UNITED STATES PATENT AND TRADEMARK OFFICE

APPLICATION NO.	FILING DATE	FIRST NAMED INVENTOR	ATTORNEY DOCKET NO.	CONFIRMATION NO.
10/612,112	07/02/2003	Jacob Fraden		3389

Office Action Summary

DETAILED ACTION

FIG. 2

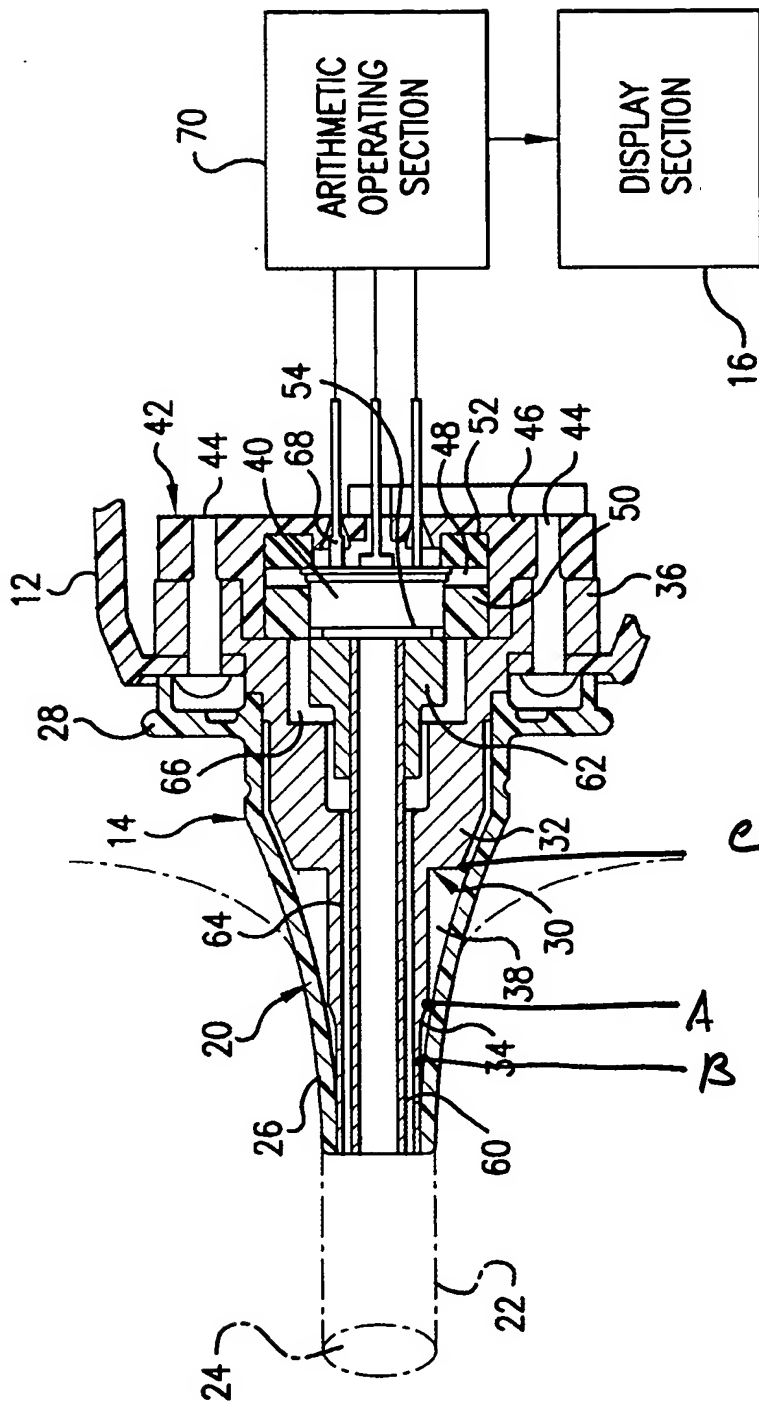
Fukura discloses in Fig. 2 a medical probe device to be inserted in a body cavity/ orifice, the device comprising an inner surface, an outer surface 32 having 2 (plurality of randomly distributed) circumferential indentations / cavities, as shown at 34 and at 30 (encircling the probe body), the indentations/ cavities are encircled by ridges A, B, C, also encircling the probe body; a heat insulating space 38 formed by the indentations is filled out/ covered with a heat insulation material (layer), inherently, having a low thermal conductivity. The skin/ probe 20 is made of a relatively thin synthetic resin (low thermal conductivity material) and, being a part of the probe, is permanently attached to the outer surface of the probe and thus, to the ridges of the outer surface of the probe. (The numerals A-C have been added by the examiner, see attachment # 2 to the Office action)
